REMSEN-LAKE PLACID TRAVEL CORRIDOR PROPOSED FINAL AMENDMENT / FINAL SUPPLEMENTAL EIS

1996 Remsen-Lake Placid Travel Corridor
Unit Management Plan /
Environmental Impact Statement

February 2016

Review of Rails-With-Trail Design Proposal by Trail with Rail Action Committee (TRAC)

TRAIL SECTION:
Tupper Lake, International Paper Conservation Easement

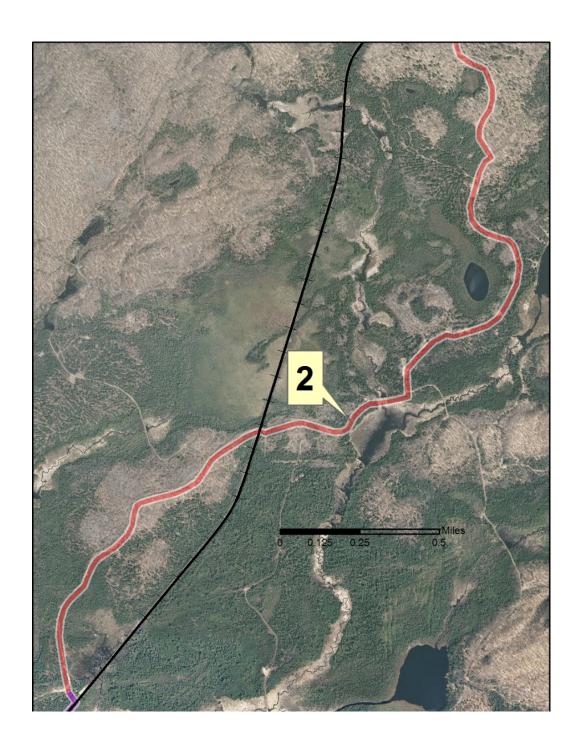
TRAC proposes to route the public "Along the Corridor" (**Map Label #1**), where an estimated 1 mile of potential wetlands would need to be filled-in to complete a parallel trail. This segment is located between Tupper Lake and the start of TRAC's alternative route off the Corridor on the conservation easement.

TRAC's suggested route off the Corridor in this segment (**Map Label #2**), could potentially become a public trail. The route shown uses logging/skid roads and traverses some very wet areas. There is potential to re-route TRAC's route through drier areas on this easement. It is important to note that the roads/trails on this property are shared with leased hunting camps and logging operations, so safety and user experiences relating to this must be taken into consideration. Snowmobiling and biking could both be theoretically possible off the Corridor in this easement.

TRAIL SECTION:
International Paper Conservation Easement to Rollins Pond

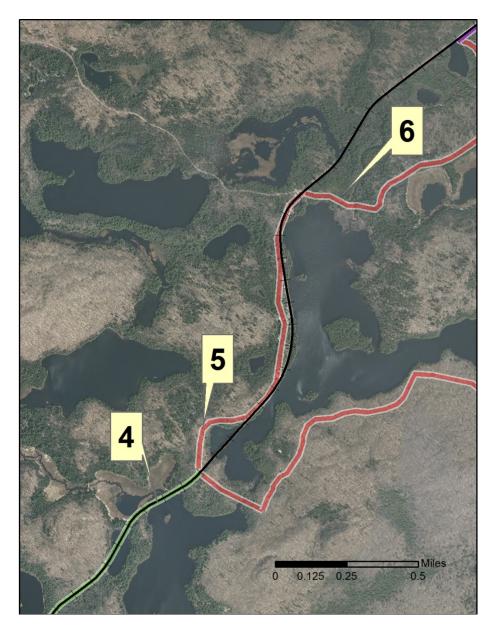
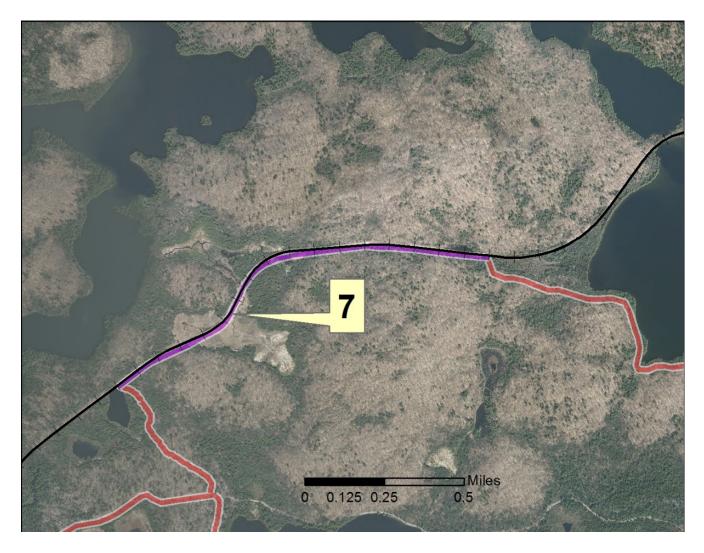
The segment of trail "Inside the Rail Corridor" TRAC proposes in the vicinity of **Map Point #3** passes through significant wetlands that would need to be filled-in, for an estimated 1/3 of a mile.

Map Point #4, a stretch that TRAC proposes to go "Inside the Rail Corridor", there is a significant causeway at a rail bridge with Rollins Pond on one side and a large wetland on the other, making it too narrow for a rail and parallel trail.

Map Point #5 shows the vicinity of Paradise Lane. This part of TRAC's alternative is probably not feasible because that road is mostly privately-owned, and therefore would require private landowner permissions.

Map Point #6 notes where a significant bridge would need to be built at the Rollins Pond outlet, in order for this alternative to be feasible. This bridge is highly desirable

from a DEC perspective for trail connections with the Rollins Pond/Fish Creek Campgrounds. That would make TRAC's Floodwood Road route possible. Some sections of TRAC's Floodwood Road loop would need to be improved and opened to public use.

Map Point #7 shows where TRAC proposes a segment approximately 0.5 miles "Along Corridor", which would result in adverse impact or loss of regulated wetlands.

Hoel Pond

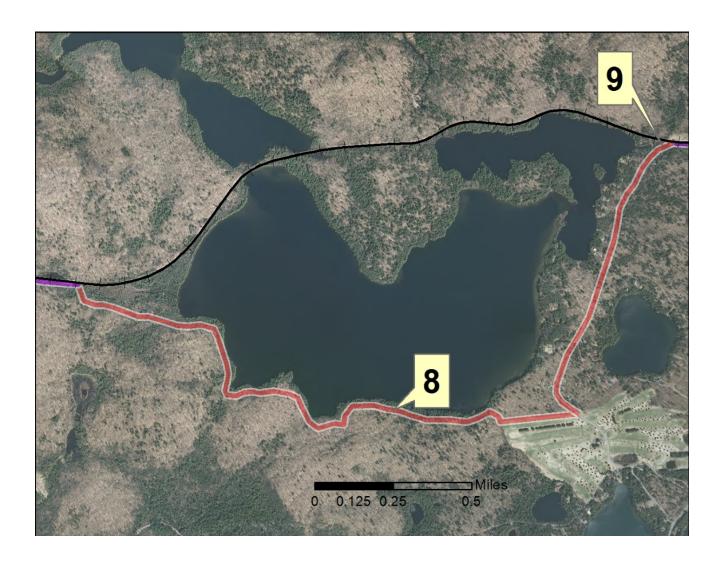
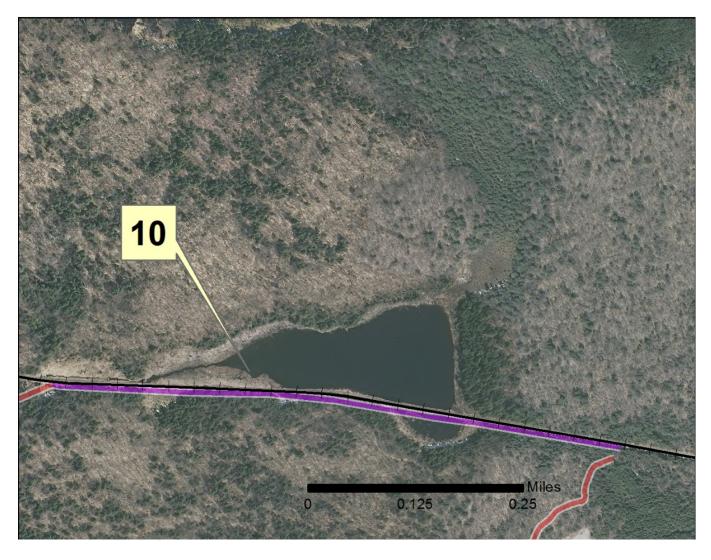
TRAC's suggested route in this map, at **Map Point #8**, goes around Hoel Pond. It starts as a herd path on the southeast side of the pond, and diminishes going west, where there are currently some primitive campsites. It is feasible that this trail system can be upgraded. This proposed segment, however, bypasses potential future access locations for people with disabilities. The Corridor offers easier water-access potential than the Hoel Pond loop.

At **Map Point #9**, shows the town road being utilized as an alternative route in the TRAC proposal, heading north from the country club, has private property at the end. Any connection to the Corridor from this road would need to be negotiated with the private landowner.

At **Map Point #10**, TRAC's "Along Corridor" segment goes through wetlands and over an open water causeway, making this proposed segment infeasible.

TRAIL SECTION:
Lake Clear (no aerial photo maps needed)

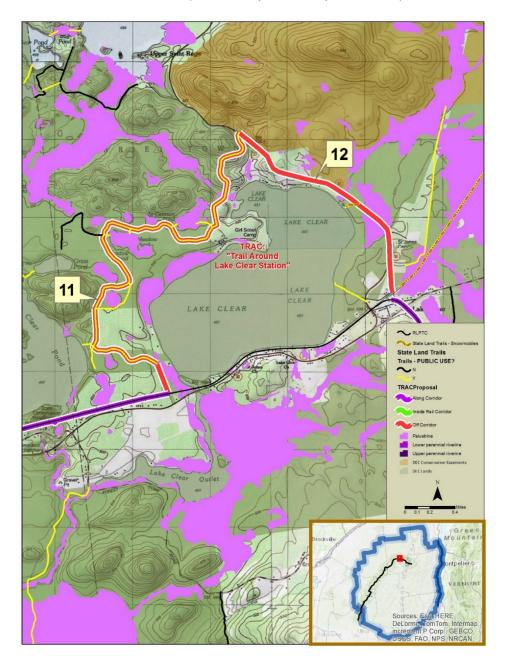
Map Point #11 - Snowmobiles and bikes are prohibited, by the Adirondack Park State Land Master Plan, in the Canoe Area.

Map Point #12 shows TRAC's segment along Route 30 which is not recommended for safety reasons, and would most likely reduce or eliminate family-oriented recreation. A possible alternative to that segment is on the north side of that road, on conservation easement land, but a crossing of Route 30 is not recommended for safety reasons, as well. Additionally, a trail on that easement would need to detour north, around significant wetlands.

TRAIL SECTION: McCauley Pond

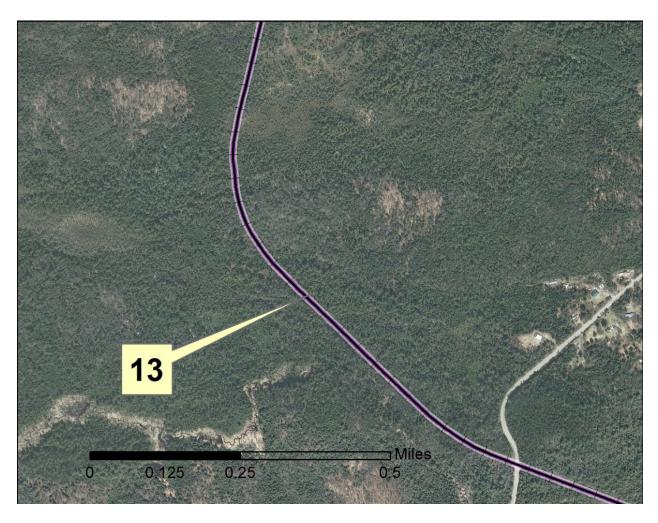
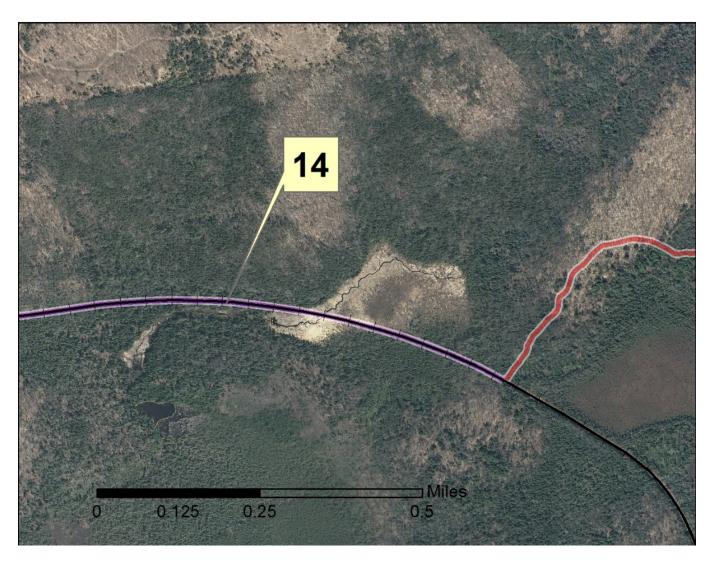
Map Point #13 shows where TRAC proposes a segment approximately 1 mile "Along Corridor", which would result in adverse impact or loss of regulated wetlands.

Map Point #14 shows where TRAC proposes a segment approximately 0.7 mile "Along Corridor", which would result in adverse impact or loss of regulated wetlands.

Lake Colby/Saranac Lake

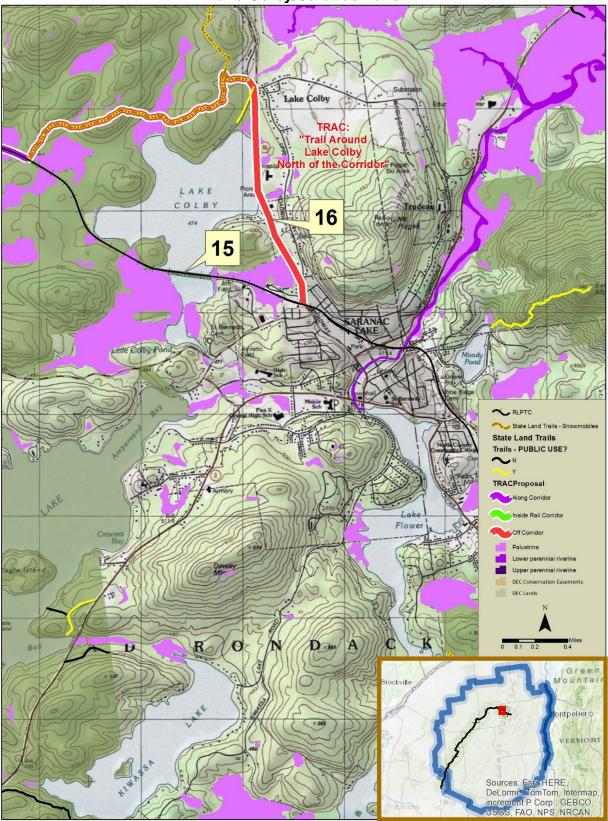
TRAC's route around Lake Colby bypasses the Lake Colby causeway (**Map Point #15**), which has potential to become fishing and paddling access for people with disabilities.
